SERVICE INSTRUCTION

ENGINE START AT LOW TEMPERATURES AT ROTAX® ENGINE TYPE 912 AND 914 (SERIES) SI-03-1998 R1

fig. 1

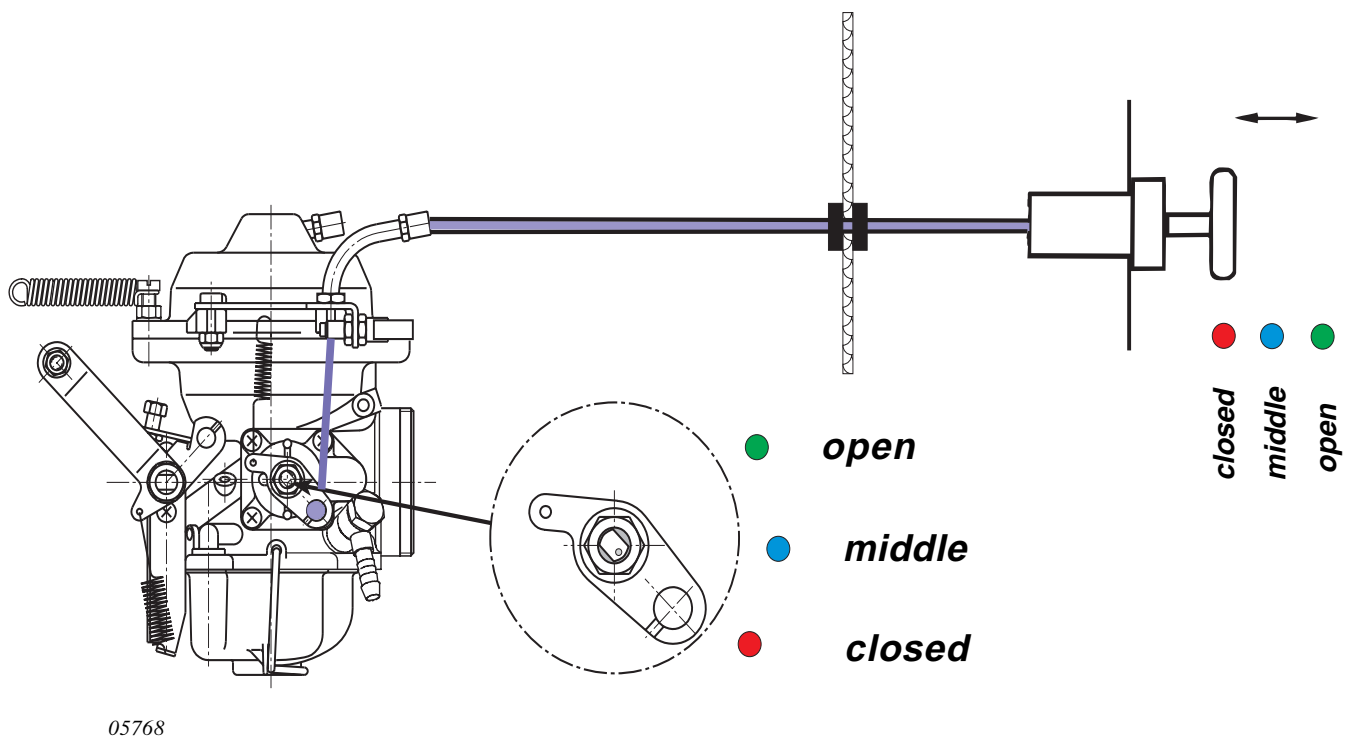
(see fig. 1 and 3)

When using a larger start jet (1), the new choke rotary disc valve (2) with changed ventilation bores (5) must also be used. This makes it possible to operate the engine at a middle setting of the cold-start system during the warm-up phase and thus get a smooth engine operation (start of serial production, see chapter 2.3).

fig. 2

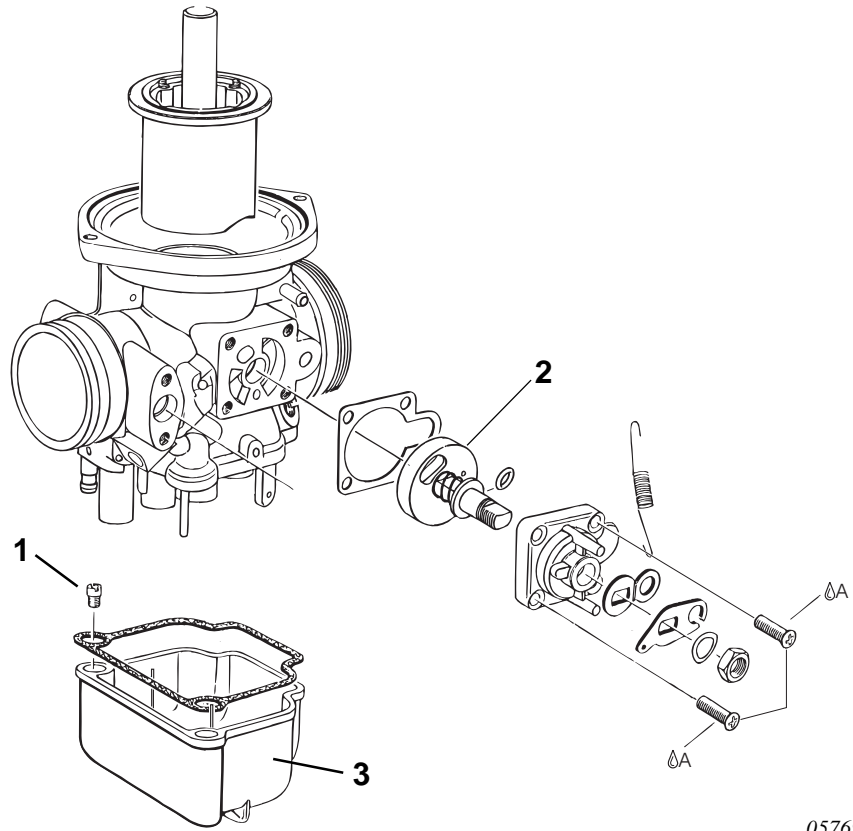
(see fig. 2)

The start jet (1) (jet 85 standard jet system) in the float chamber (3) must be exchanged for an applicable larger jet (1). Jets of the following sizes can be selected depending on the usual atmospheric conditions and the cold start behaviour of the engine:

Jet 105, 120, 130 or 140 (see chapter 2.4).

◆ NOTE: The jets (1) are selected by trial and error, but it must be noted that the fuel-air mixture can be highly enriched and can lead to a fuel over-enrichment in very bad cases.

fig. 3

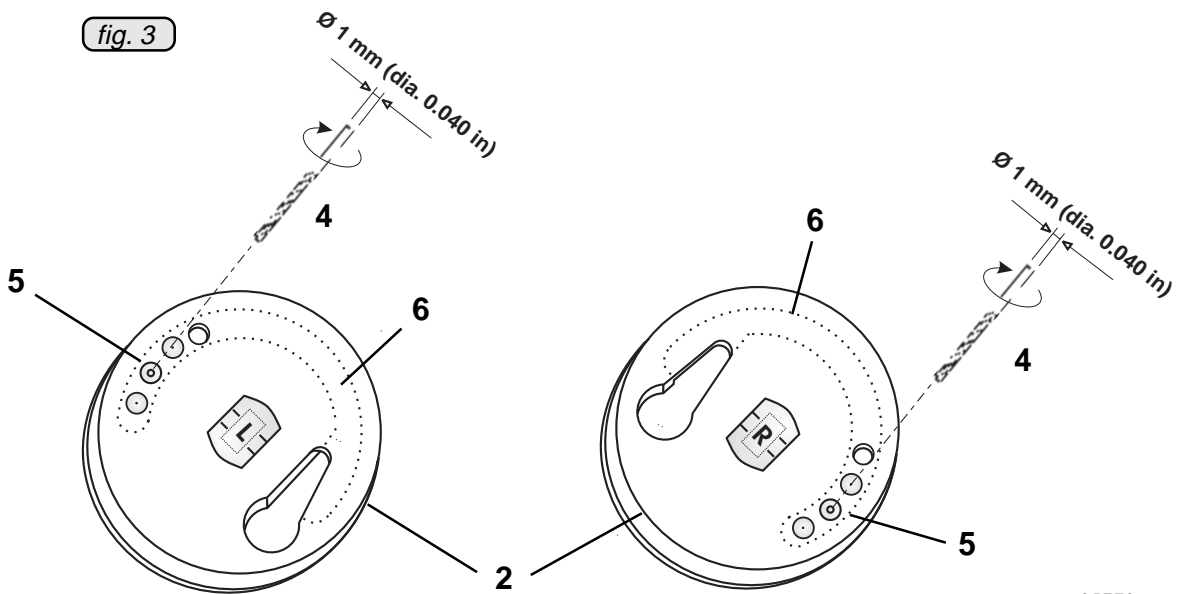
(see fig. 3)

After removing the choke rotary disc valve (2), the ventilation hole (5) of \varnothing 0.65 mm must be redrilled to \varnothing 1 mm.

■ CAUTION: The rotary disc valve channel (6) must be fully cleaned of chips after the machining!
